SHIRE OF CARNARVON  
**SCHEDULES**  
SPECIAL COUNCIL MEETING  
TUESDAY 10 JANUARY 2023

# 85 OLIVIA TERRACE, CARNARVON - PROPOSED MIXED-USE DEVELOPMENT (HOTEL, RETAIL/COMMERCIAL, OFFICES, SHORT-STAY APARTMENTS AND MULTIPLE DWELLINGS)

## Form 1 – Responsible Authority Report (Regulation 12)

6 - GROUND FLOOR & SITE PLAN 1:200

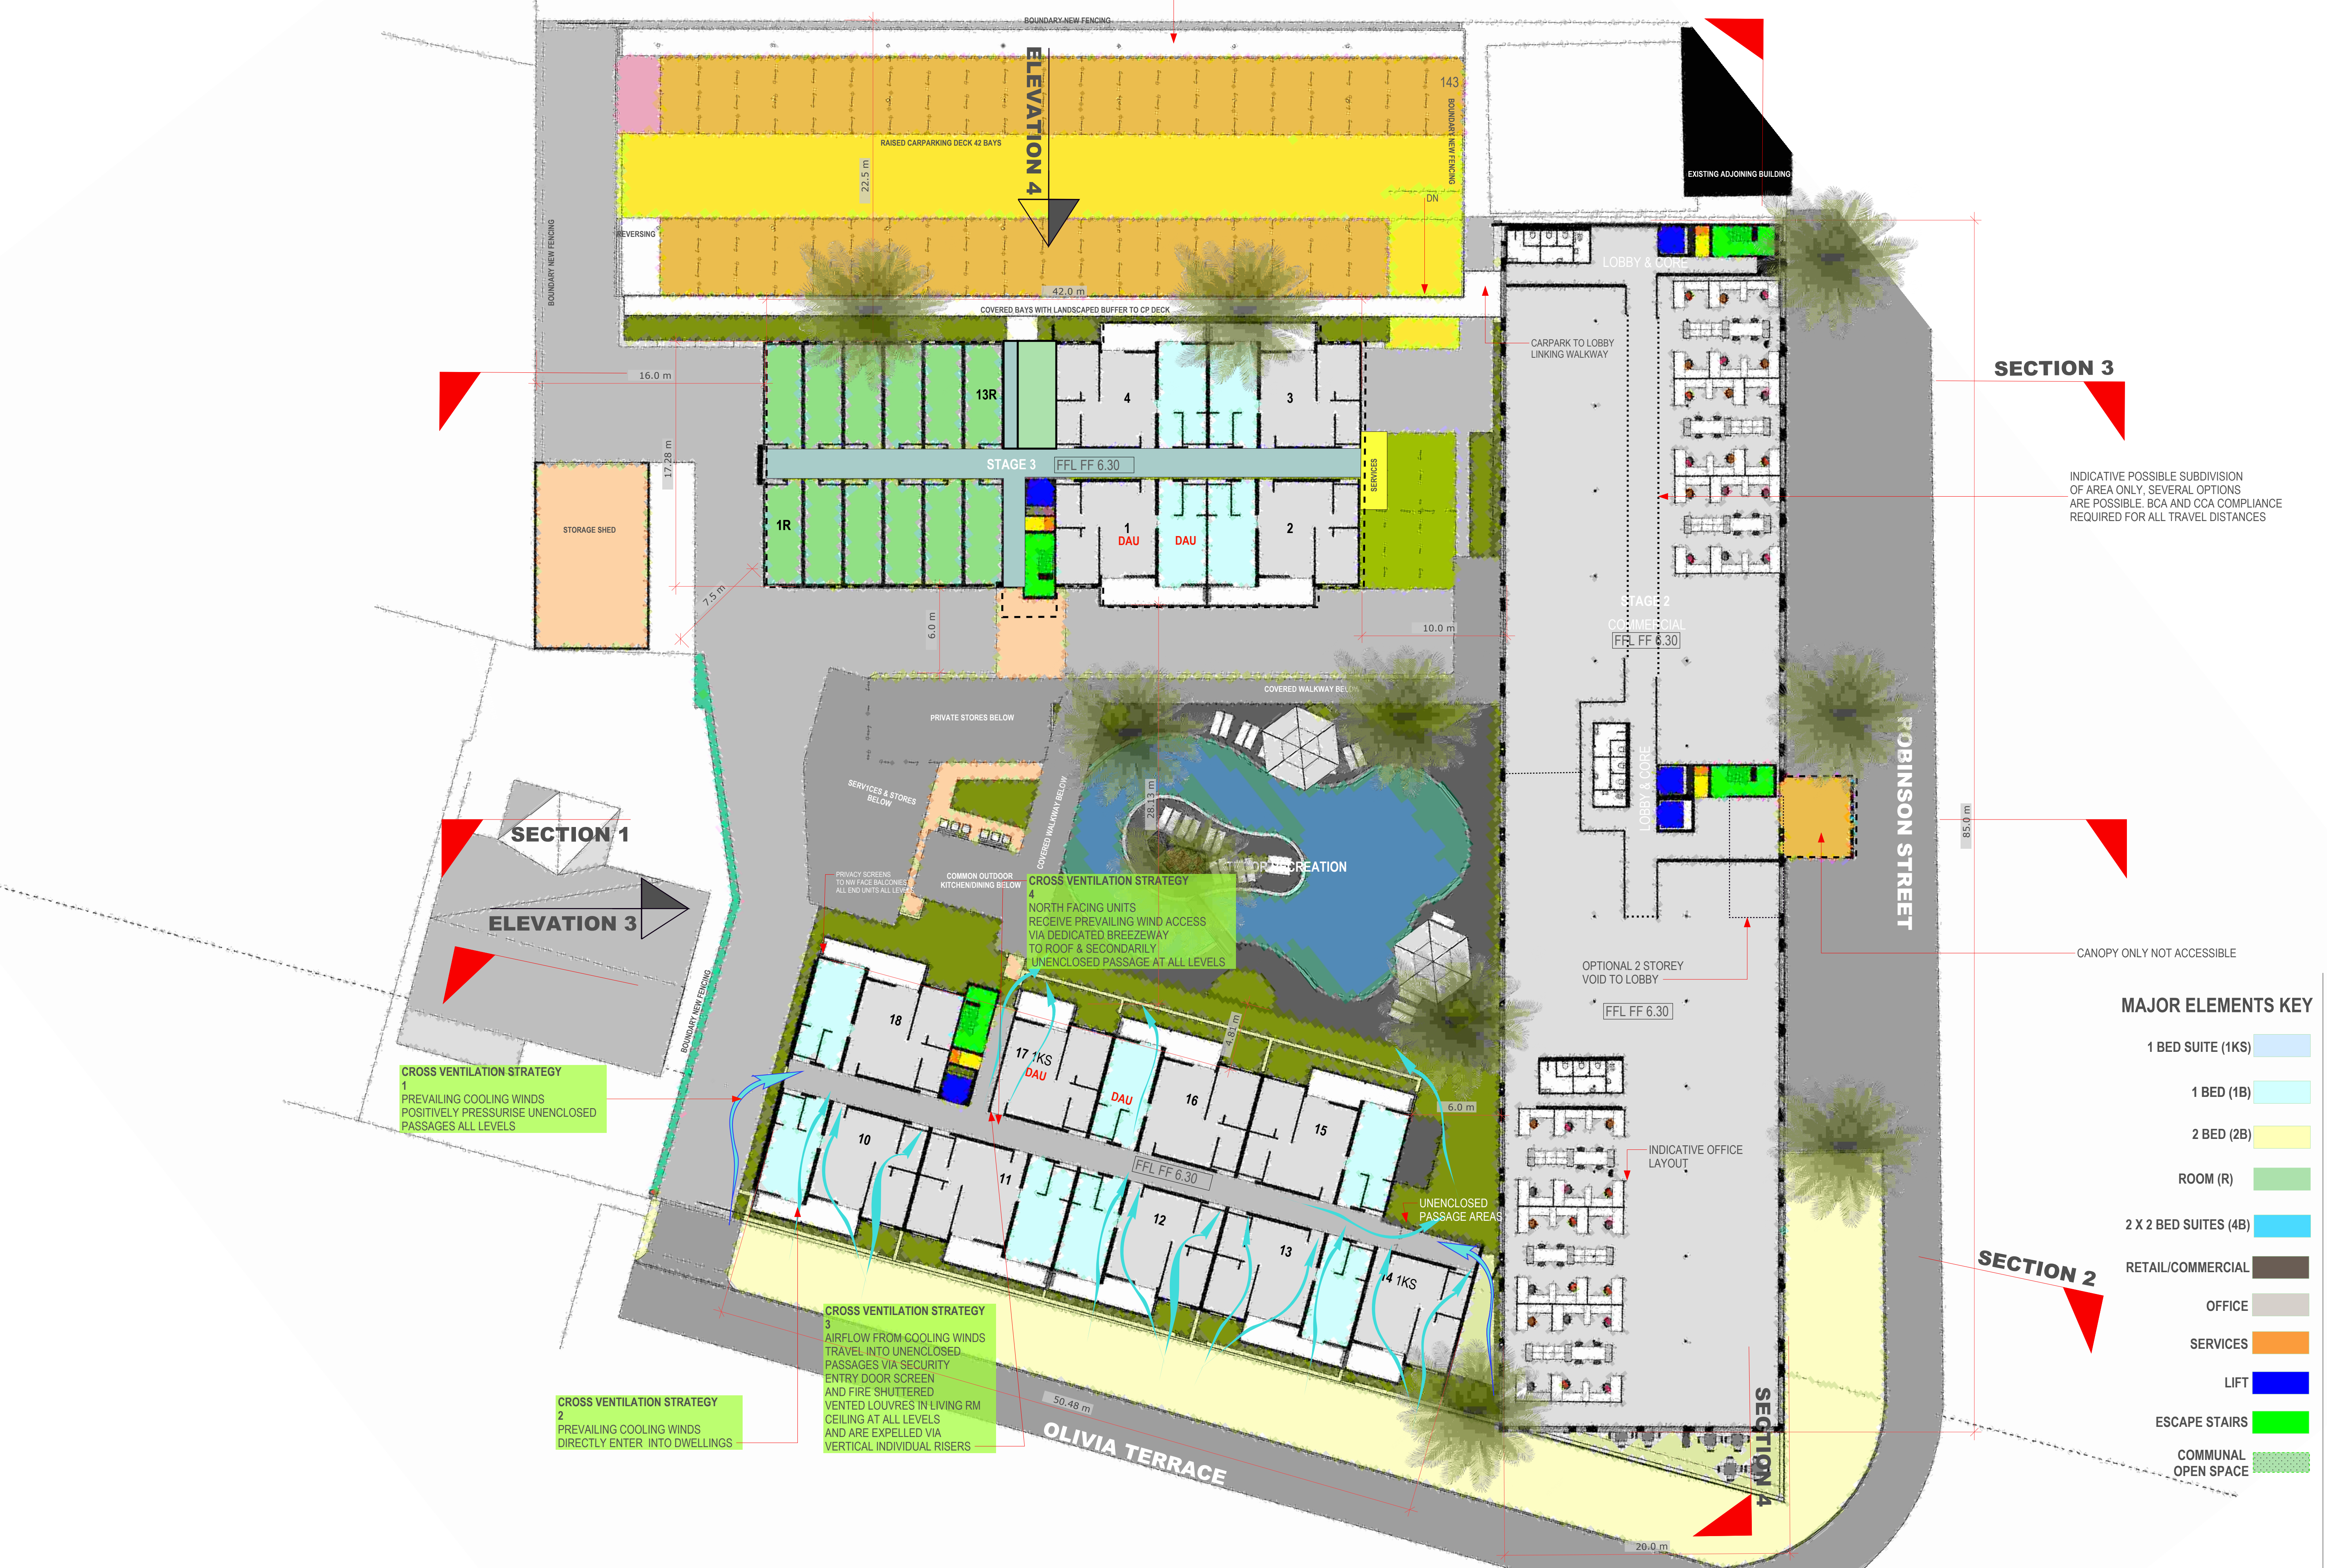
**Acceptable Outcome A4.5.1** of the R-Codes Vol 2 prescribes circulation corridors to be a **minimum width of 1.5 metres**. The proposed corridor widths adjacent to the stairs and lifts have been measured at 1.4 metres wide when scaled from the accompanying floor plans.

The proposed waste bin compound will be visibly shielded from Olivia Terrace for the storage of waste bins, which is considered acceptable. However, no detail was provided on the management of waste disposal for the development. This will be addressed via a condition of development approval.
